05V-545
(16 pages)
EQ05-027

Safety Defect and Noncompliance Report Guide for Vehicles
PART 573 Defect and Noncompliance Responsibility and Reports¹

Subject: Tuthill Transport Technologies Recall No. 0509 - Certain Models 20/22 AR and RS3162 Trailer Suspensions - Beam/Axle Pivot Connection Joint

49 CFR PART 573 - DEFECT INFORMATION REPORT
TUTHILL TRANSPORT TECHNOLOGIES RECALL NO. 0509 - CERTAIN MODELS 20/22 AR AND RS3162
TRAILER SUSPENSIONS - BEAM/AXLE PIVOT CONNECTION JOINT

EXHIBIT B

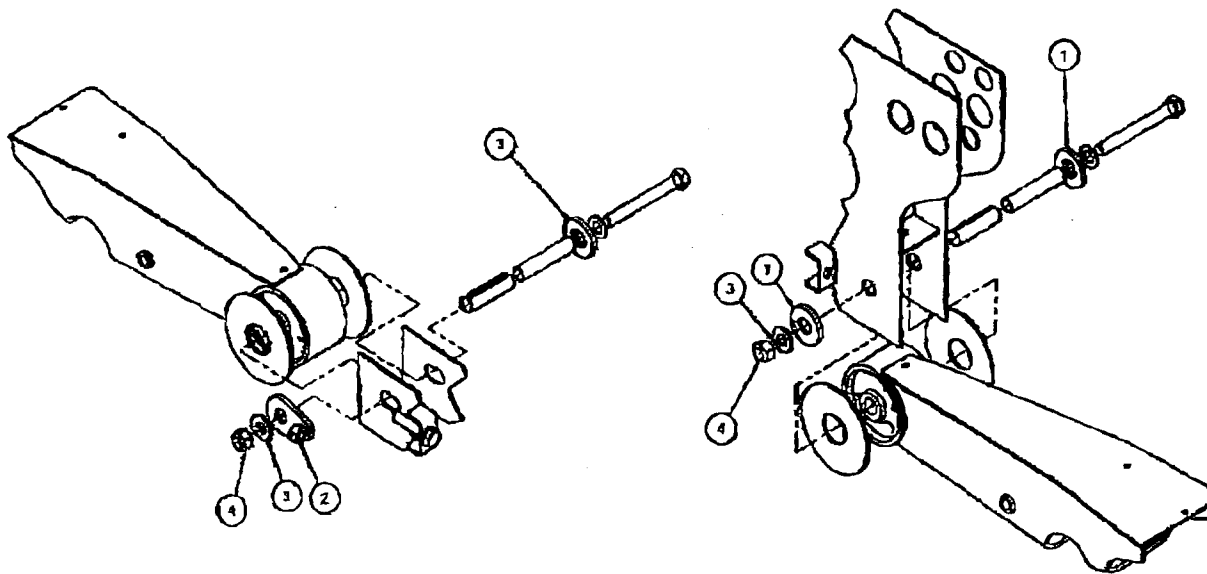
REWORK KIT # K705971					
ITEM NO.	PART NUMBER	DESCRIPTION	QTY. PER PMOT CONNECTION		QTY. PER KIT
			ADJUSTABLE	NON-ADJUSTABLE	
1	23556-02	REY-ALIGN FLANGE WASHER	1	2	6
2	23573-02	REY-ALIGN ASSEMBLY	1	0	2
3	23952-01	DISC SPRING WASHER (7/8 ID)	1	1	4
4	14345-01	LOCK NUT - 7/8-14UNF-2B, CLASS C	1	1	4

- Rework each unit with the new chamfered washer, a chamfered Rey-Align[®] Assembly and Rey-Align[®] washer, with the goal to retrofit, as possible, every beam/axle pivot bolt connection joint (4 per unit) by March 31, 2006;
- Repair all parts associated with the beam/axle pivot bolt connection joint that show signs of wear by March 31, 2006; and,
- Align all units immediately subsequent to the rework or repair.

All units will be "reworked," (Exhibit B) and those needing further work will be "repaired," (Exhibit C). A separate remedy will be utilized for Great Dane trailers. (Exhibit D). To achieve this, Tuthill Transport Technologies is deploying sixteen teams equipped with parts and tools to rework or repair as required all units at:

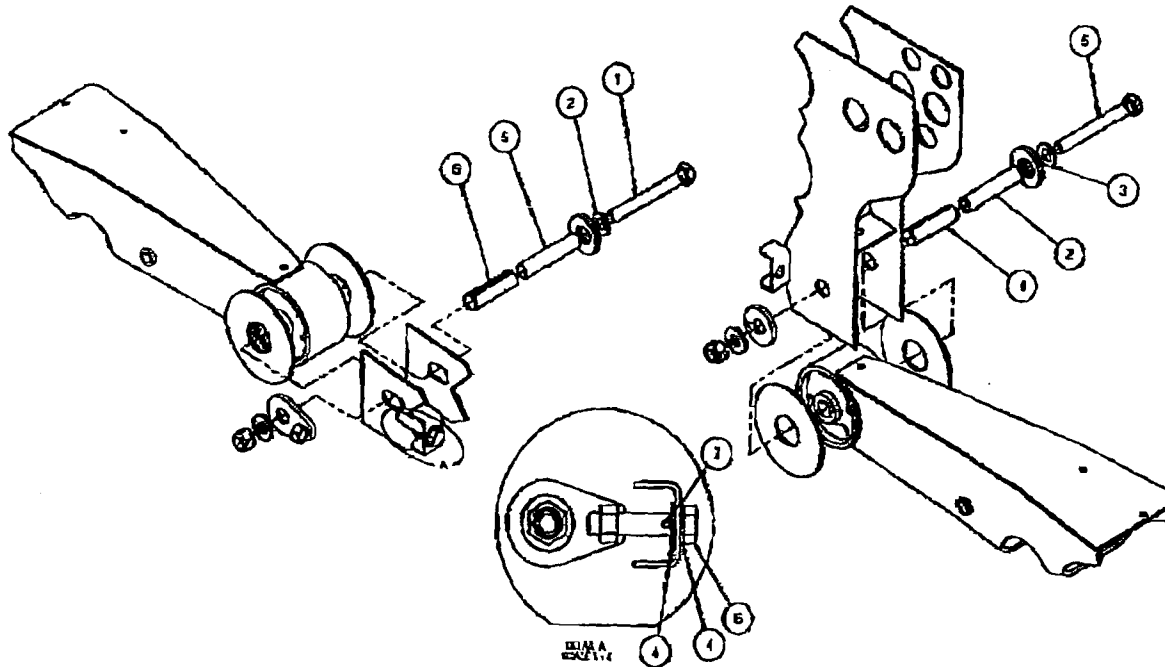
NOTES: 1) FOR REPAIR, REWORK KIT K705971 IS ALSO REQUIRED
 2) ONE REPAIR KIT REQUIRED PER AXLE

GREAT DANE UPDATE KIT # K705979				
ITEM NO.	PART NUMBER	DESCRIPTION	QTY. PER PIVOT CONNECTION	QTY. PER KIT
1	23286-02	BOLT, 7/8-14UNF-2A x 7.5 LONG, GRADE 8	1	4
2	T-7292	WASHER (7/8)	1	4
3	23952-01	DISC SPRING WASHER (7/8 ID)	1	4
4	14345-01	LOCK NUT - 7/8-14UNF-2B, CLASS C	1	4

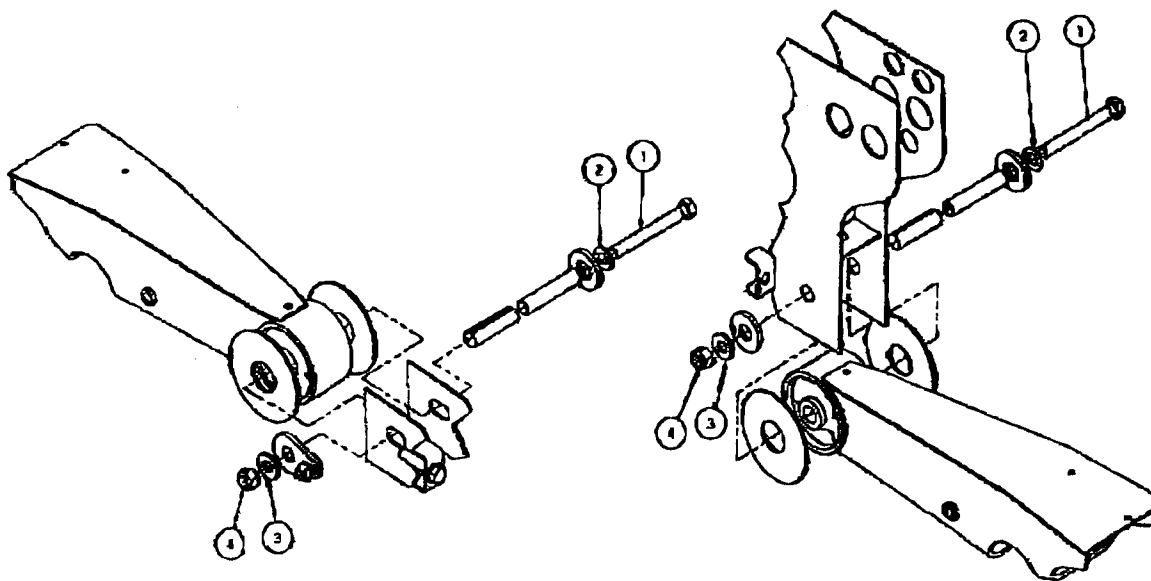
NOTE: ONE UPDATE KIT REQUIRED PER SUSPENSION
